Reference: Provo Regional Center HVAC & Controls Upgrade
DFCM Project No. 05031310

Subject: **Addendum No. 1**

Project Name: Provo Regional Center HVAC Upgrade

Addendum No.: 1

ME102—ADDENDUM #1 10-5-05

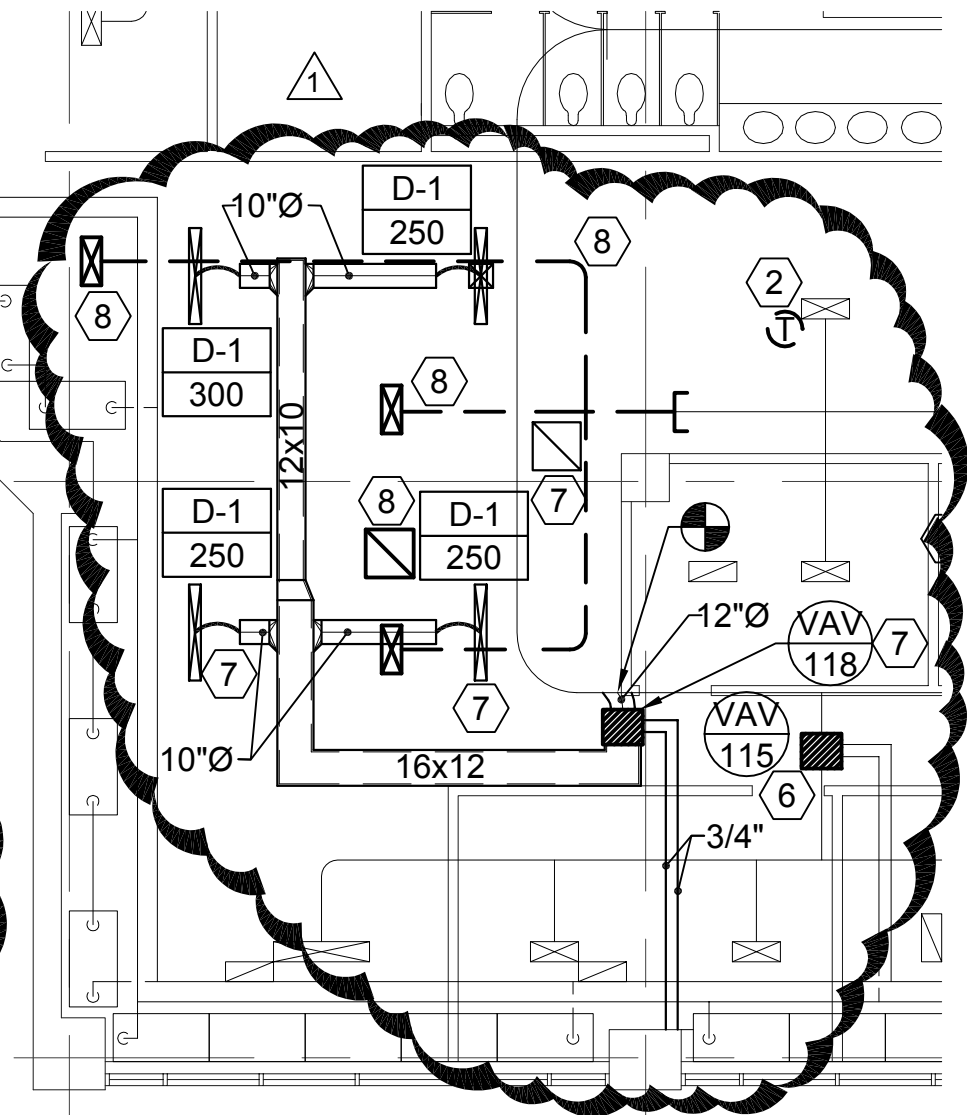
- Item VI-3.** ME102: Provide a new VAV box and associated ductwork, grilles, hot water piping, etc. for the clinic area. See attached 8-1/2 x 11 drawing ME103 Addendum #1.

- 7 PROVIDE A NEW VAV BOX FOR THIS AREA. PROVIDE NEW LOW PRESSURE DUCT, DIFFUSERS, RETURN GRILLES AS SHOWN. TIE INTO EXISTING HOT WATER PIPING AND EXISTING MEDIUM PRESSURE DUCT.
- 8 REMOVE EXISTING LOW PRESSURE DUCT, DIFFUSERS, AND RETURN GRILLES. CAP EXISTING LOW PRESSURE SUPPLY.
